Point Beach Nuclear Plant, Units 1 and 2
Dockets 50-266 and 50-301
Renewed License Nos. DPR-24 and DPR-27

License Amendment Request 261, Supplement 4
Extended Power Uprate

LICENSE AMENDMENT REQUEST 261, SUPPLEMENT 4 EXTENDED POWER UPRATE

**TRAIN "A" EMERGENCY DIESEL GENERATOR
VOLTAGE AND FREQUENCY PROFILES
LARGE BREAK LOSS OF COOLANT ACCIDENT
WITH LOSS OF OFFSITE POWER**

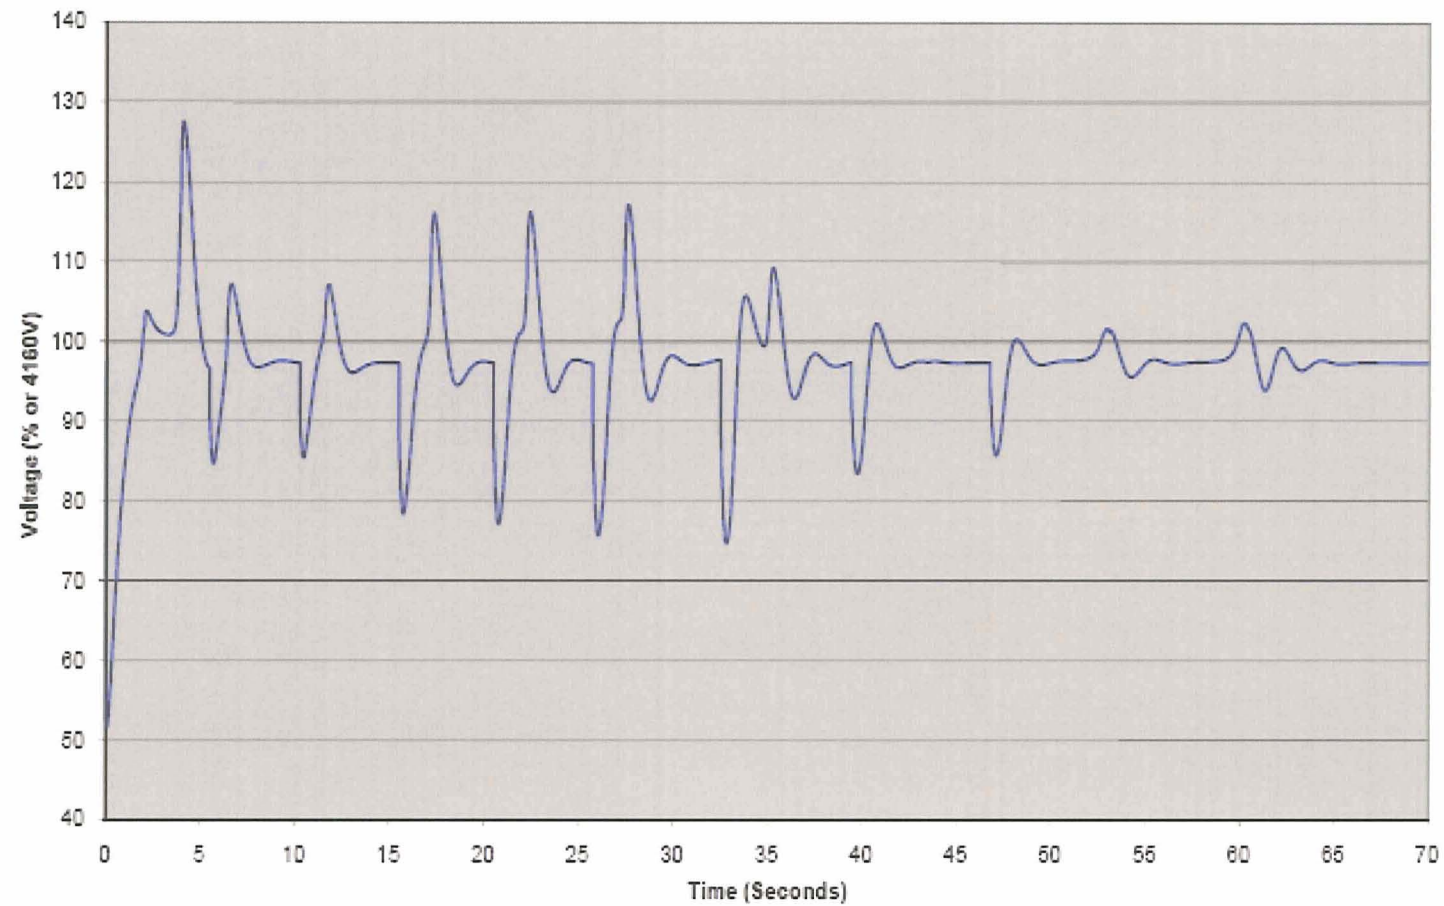
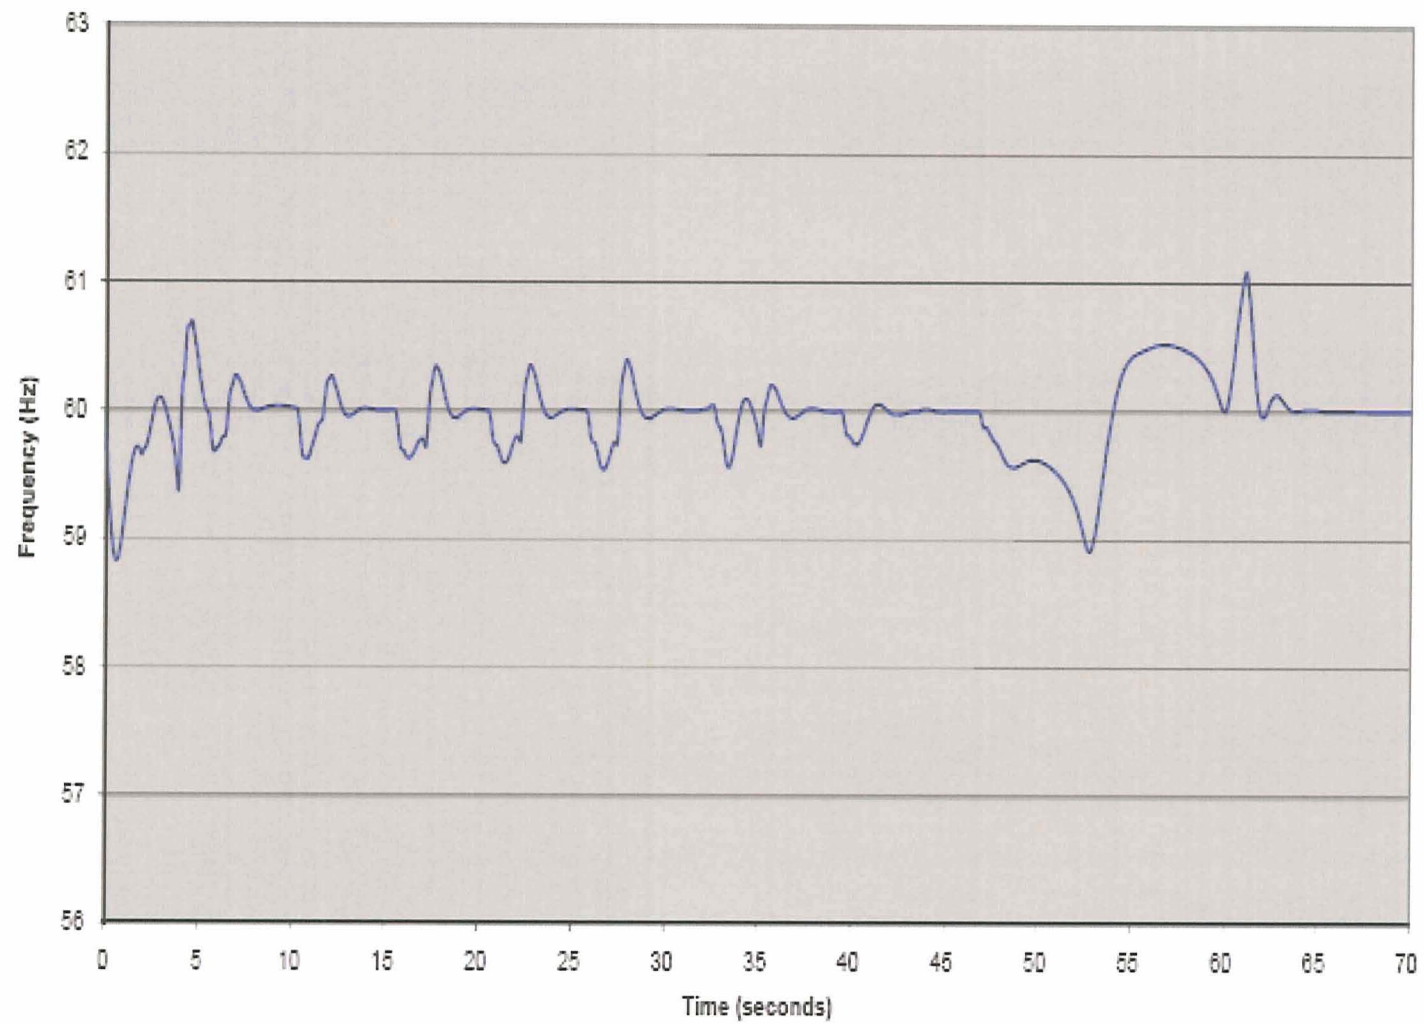
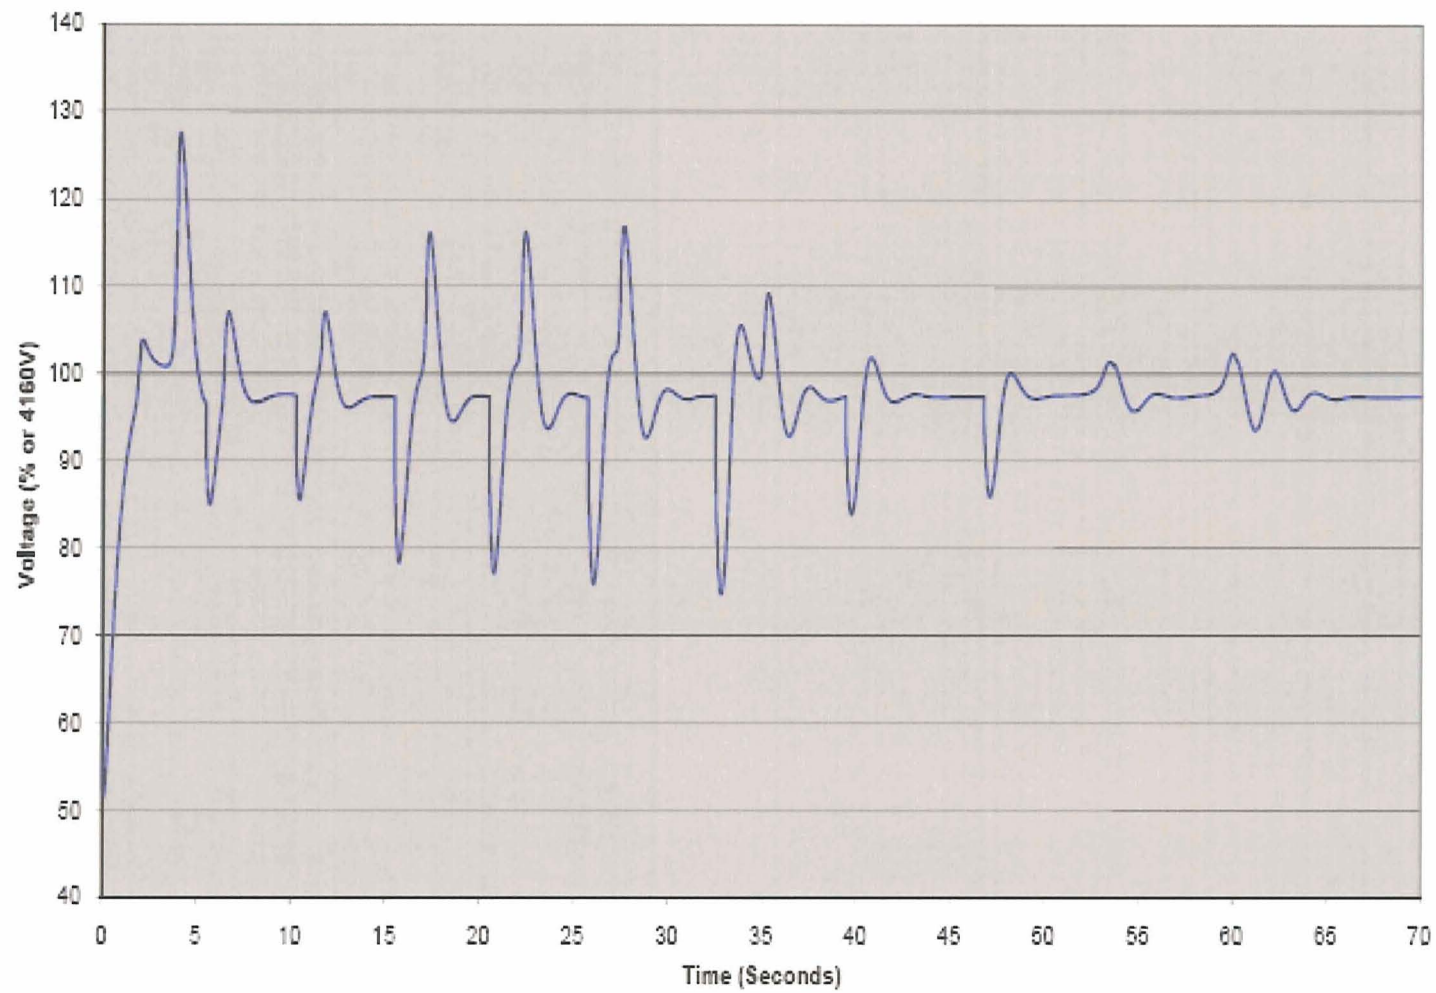
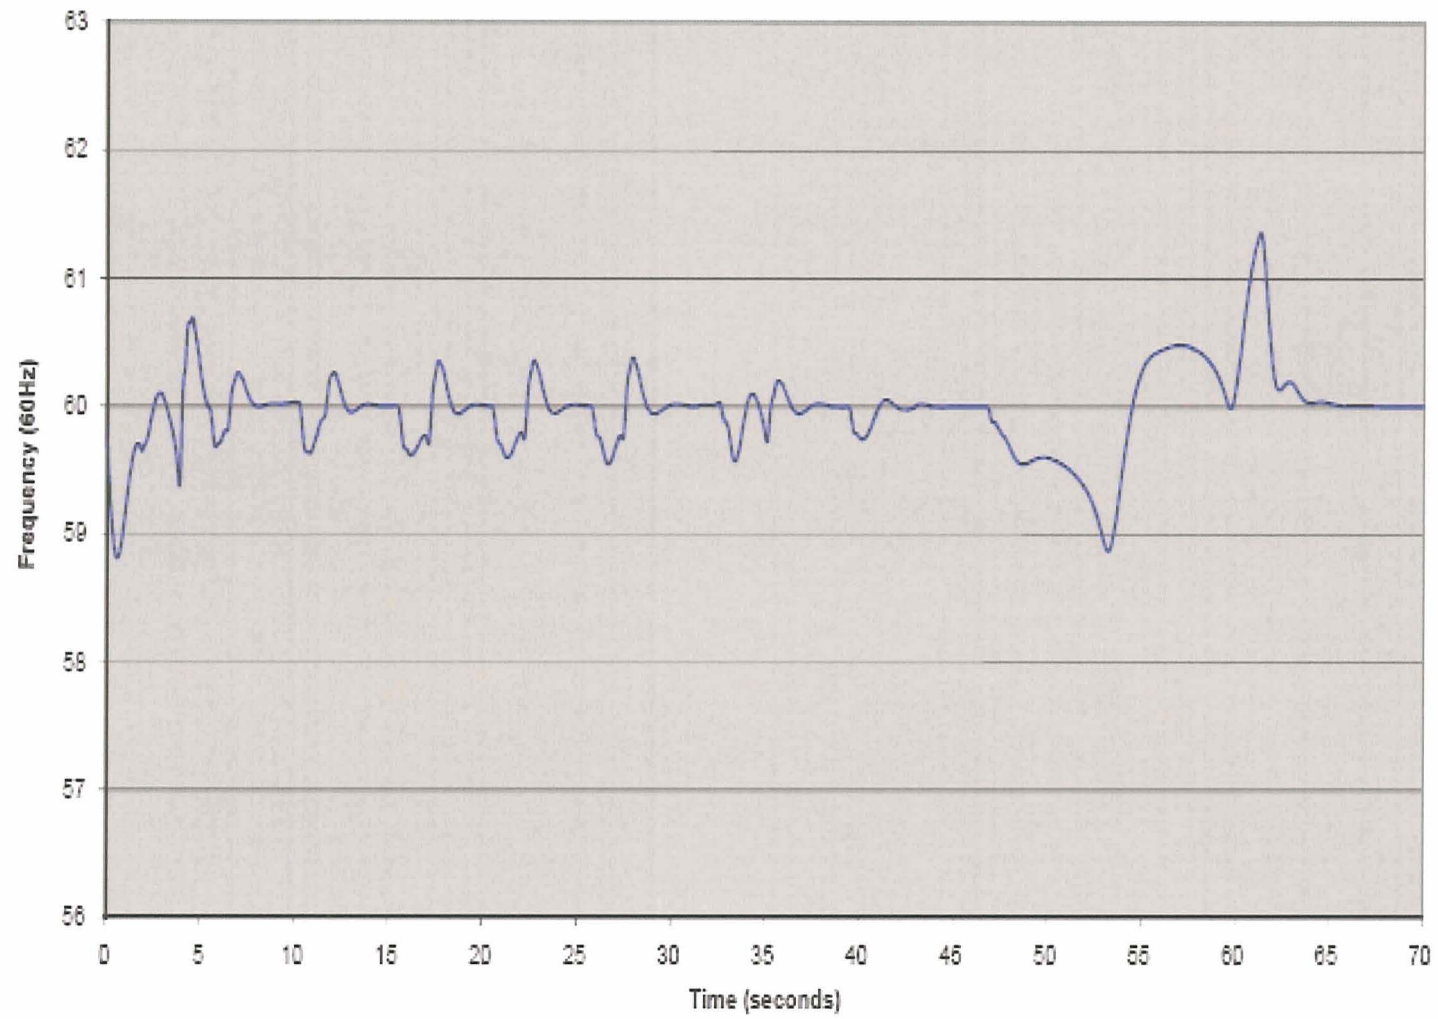
In response to staff's request for additional information (RAI) dated August 26, 2009, regarding the emergency diesel generator (EDG) voltage dip below the acceptance limit of 75 percent nominal voltage during motor start, the licensee stated that the EDGs are capable of starting safeguard loads, and the voltage recovers quickly to the acceptable level. Based on staff's review of the dynamic loading calculations, the staff notes that under certain loading conditions for Train "A" EDG, the frequency is outside 2 percent margin, the worst-case voltage dip is 45-48 percent and the voltage overshoot is 129.5 percent. Train "A" voltage and frequency variations are outside the industry accepted standards and guidance. Provide detailed analyses regarding the downstream effects on components such as contactors, control fuses, inverters, battery chargers, solenoids, motor-operated valves, solid state devices, etc., and the basis to show that all required loads will start and continue to run with sufficient margins after accounting for any uncertainties. Provide justification for the performance capabilities of the EDG "A" regulator and excitation systems to support shutdown equipment within design-basis requirements during a design-basis accident. The staff notes that Train "B" EDG bus voltages remain above 75 percent of nominal voltage, consistent with NRC Regulatory Guide (RG) 1.9, throughout the motor starting sequence in all postulated loading conditions. Provide a summary of all bus voltages for the 'B' train distribution system.

The following ETAP cases were performed in the dynamic loading calculation to address large break LOCA design basis accident loading conditions for the Train "A" EDGs G01 and G02.

Case #	Case Description
8-1	EDG G-01/G-02 Unit 1 LOOP/LOCA with Unit 2 LOOP.
9-1	EDG G-01/G-02 Unit 1 LOOP with Unit 2 LOOP/LOCA.

The EDG voltage and frequency traces for these cases are included in Attachment 1. Other non-large break LOCA design basis accident ETAP cases were also performed for the Train "A" EDGs in which the containment spray pump starts in later load blocks. These cases also demonstrate the sequenced loads will successfully start, accelerate their driven equipment, and meet criteria evaluated above. The bounding worst case non-large break LOCA design basis EDG voltage and frequency traces are provided in Attachment 2.
